REVISIONS		
MARK	DATE	DESCRIPTION
1	1/24/25	ADDENDUM 1

PROJECT:
DEWITT SPAIN AIRPORT APRON REHABILITATION

SHEET TITLE:
**ADDENDUM NO. 1
 APRON SECTION
 WITH DETAIL
 REFERENCES**

SHEET TITLE:
TYPICAL SECTIONS

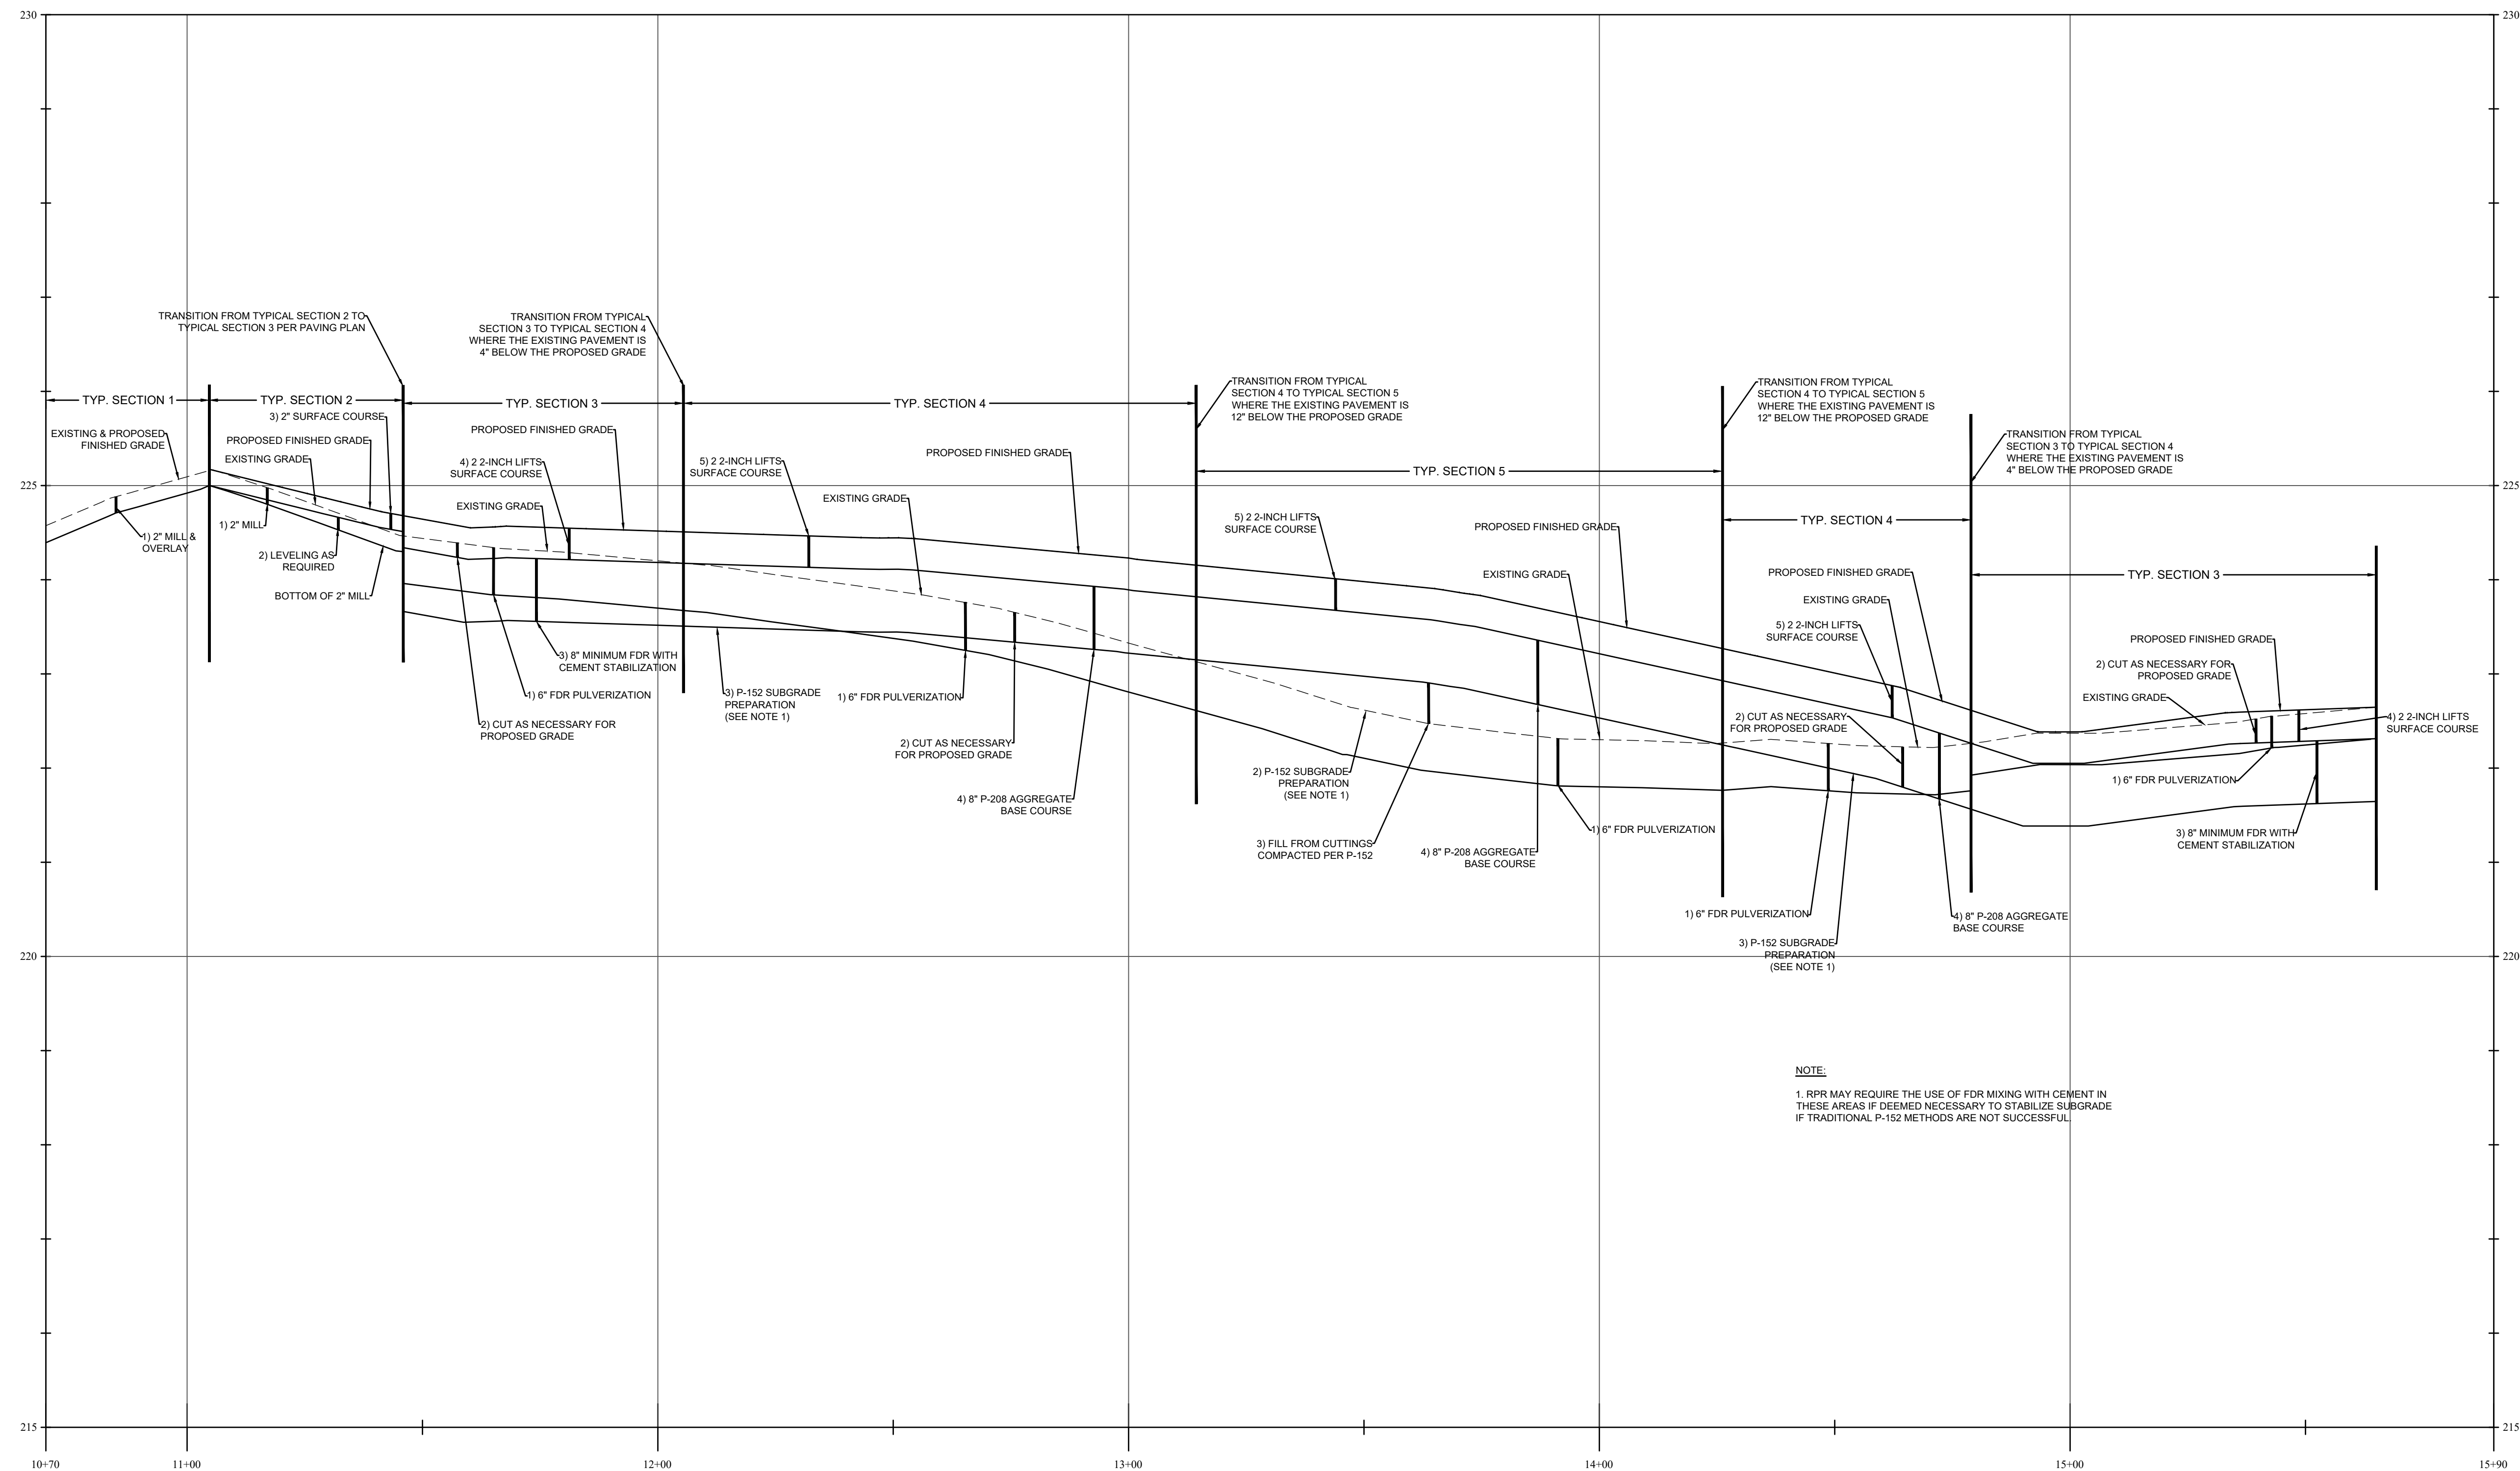
NOTE:
 1. RPR MAY REQUIRE THE USE OF FDR MIXING WITH CEMENT IN THESE AREAS IF DEEMED NECESSARY TO STABILIZE SUBGRADE IF TRADITIONAL P-152 METHODS ARE NOT SUCCESSFUL.
